Narrabri Gas Project Supplementary response to submissions

Supplementary response to submissions

Several statutory bodies, including state and local Council, provided further questions upon reviewing the RTS. This supplementary RTS (SRTS) document provides responses to those questions.

Figure 2-1 Indicative locations (stars) of additional monitoring locations to provide the highest worth monitoring (*cf.* Sreekanth *et al.* 2018a).

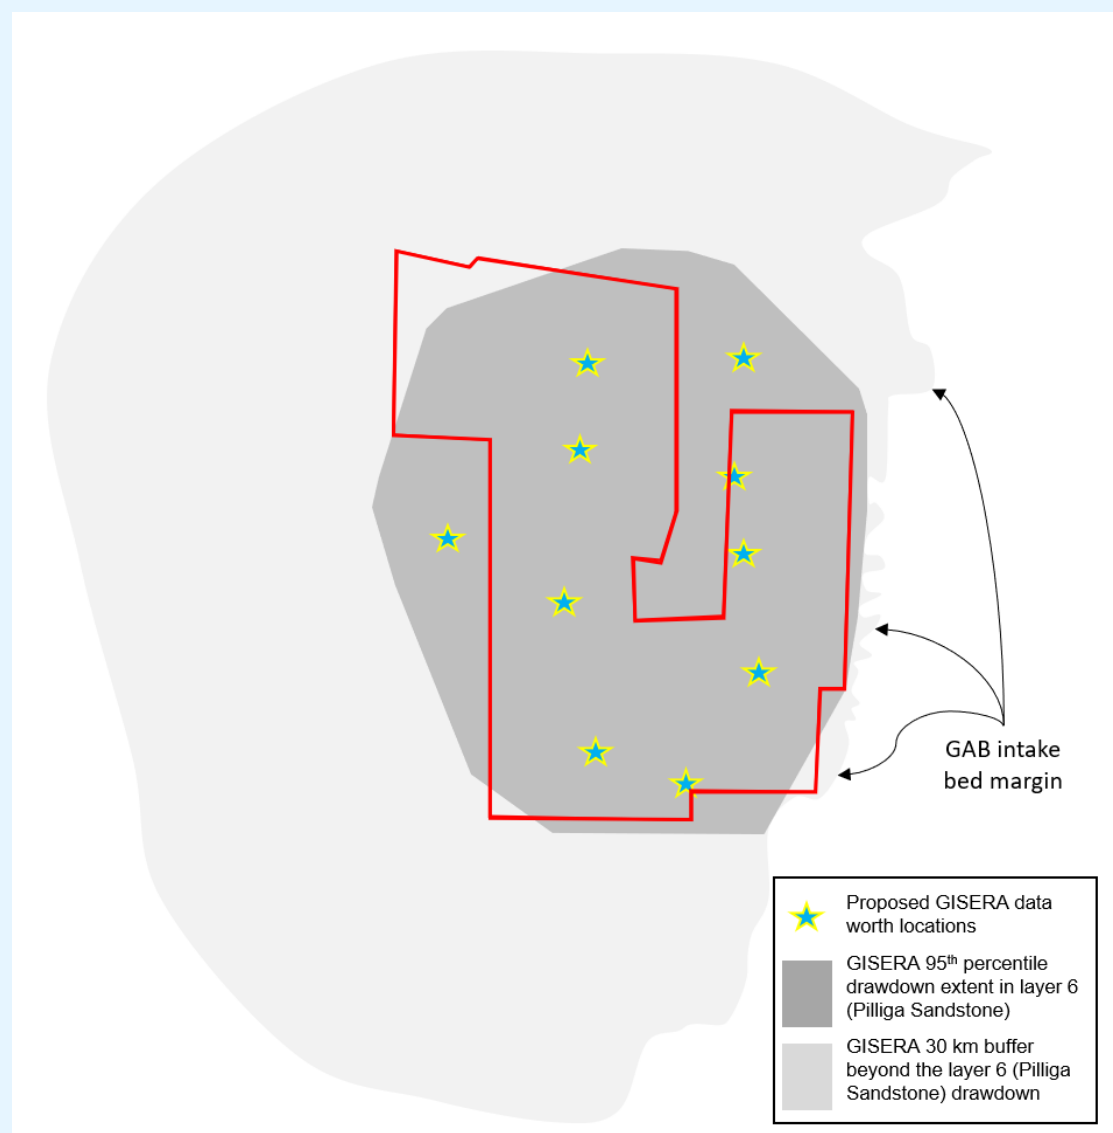
The submission stated that Management Response Triggers (MRTs) are to monitor and manage impact propagation based on groundwater impacts (drawdown and timing) being no greater than those predicted from the 'Base Case' modelling scenario as documented in the EIS. The triggers and responses are grouped into three tiers, with each tier referring to a connected, or group of connected, water sources.

As noted in section 3 of the Water Monitoring Plan (EIS Appendix G3), the proponent is committed to delivering a groundwater monitoring network that “informs to the extent possible, an understanding of whether or not the project is contributing to changes in water quantity or quality within water assets, particularly the high-value groundwater sources in the Great Artesian Basin and alluvial aquifers”.

Independent modelling by the Commonwealth Scientific and Industrial Research Organisation (CSIRO) for the GISERA program (e.g. Sreekanth *et al.* 2018a) has demonstrated that highest worth monitoring is that within the potential project impact area as shown in Figure 2-1.

The light grey region in Figure 2-1 represents the 30 km buffer region of modelled interest, while the dark grey constrains the extent of potentially observable drawdown in layer 6 of the model, representing the Pilliga Sandstone.

Greatest data worth is achieved by monitoring formations immediately above the target coal seams within the project area. Optimal additional monitoring locations for Upper Gunnedah-Oxley Basin and Lower Great Artesian Basin formation targets (Sreekanth *et al.* 2018a).

Figure 2-3 Upper disturbance limits by vegetation class

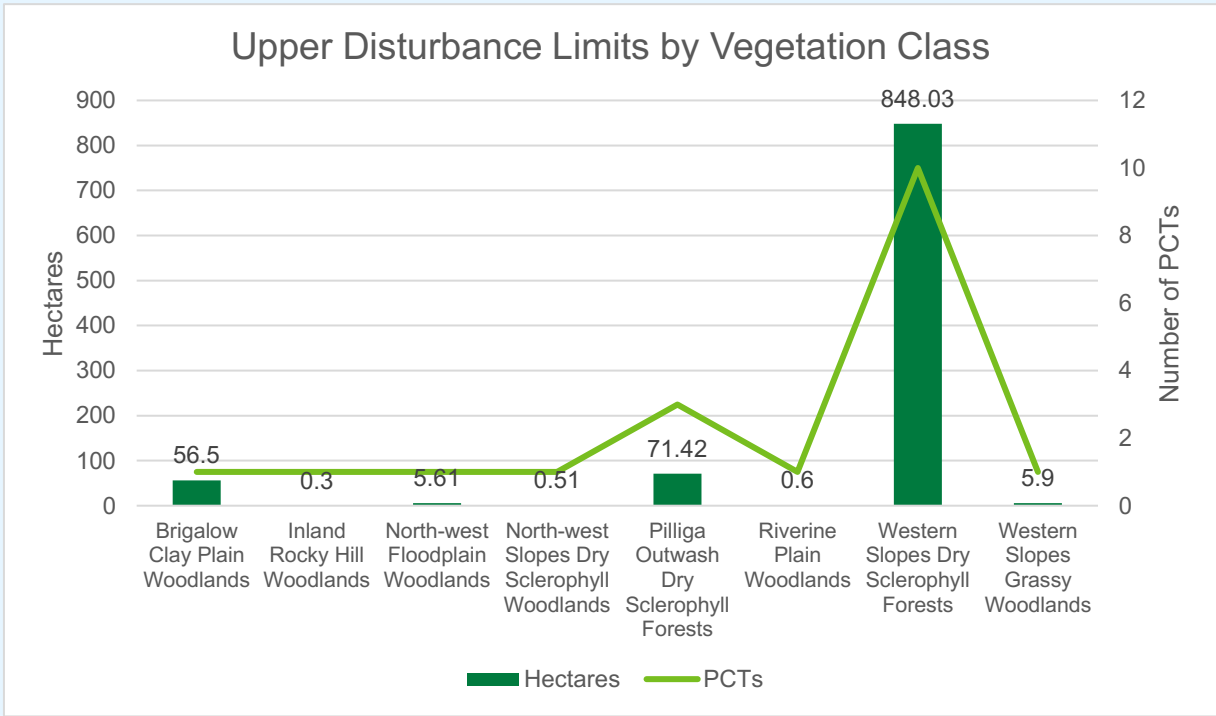
The submission recommended that should the Plant Community Type (PCT) not be as mapped, the impact may be tracked against the upper disturbance limits for the mapped PCT should it be in the same vegetation class as the impacted PCT.

A review of the Upper Disturbance Limits for direct impacts has been undertaken by PCT and Vegetation Class Combinations (refer Figure 2-3). Of a total 988.8 hectares, 85.8 per cent occurs within the Western Slopes Dry Sclerophyll Forests Vegetation Class which includes 10 of the 19 PCTs directly impacted by the project.

Only two other Vegetation Classes, namely Brigalow Clay Plain Woodlands (5.7 per cent) and Pilliga Outwash Dry Sclerophyll Forests (7.2 per cent), have more than one per cent of the Upper Disturbance Limit for direct impacts for the project. Six Vegetation Classes in the project area are represented by only one PCT each, and the combined Upper Disturbance Limit for these Vegetation Classes is only seven per cent of the total Upper Disturbance Limit for direct impacts.

There are a number of Vegetation Classes which are structurally and floristically related, namely North-west Slopes Dry Sclerophyll Woodlands, Pilliga Outwash Dry Sclerophyll Forests and Western Slopes Dry Sclerophyll Forests. There is limited material available (only Keith 2004) which would allow a field ecologist to accurately assign a Vegetation Class in the field.
